## **EZ Hauler 3500/3800/4100 Product Announcement**

**Subject:** Sealing module connectors

**To:** EZ Hauler 3500/3800/4100 Owners      **Announcement:** CCG1963

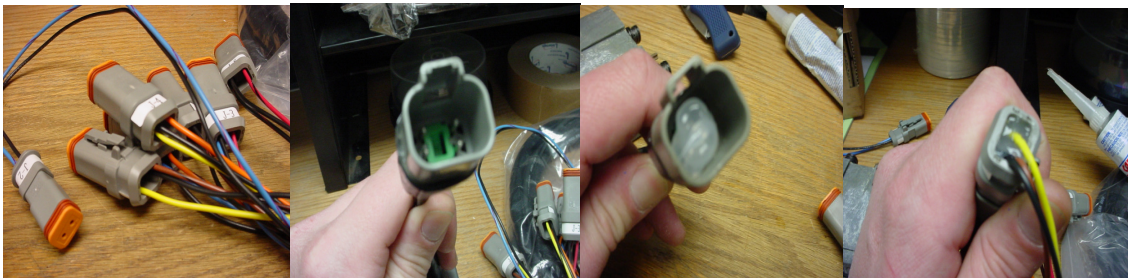
**EZ Hauler models 3500/3800/4100 manufactured prior to March 12, 2008 could experience hydraulic module failure. Failure to update could result in total hydraulic module failure!**

**This is a mandatory update. First locate the remote wiring harness at the top of crane valve. To do this update, pull connector shell of remote harness apart from module connector & place a “thumbnail size” of dielectric grease inside, then reconnect the harness to the module. You will then need to seal the backside of the remote wiring harness with silicone. This fix will prevent water from entering the connectors & disrupting the function of the remote control.**
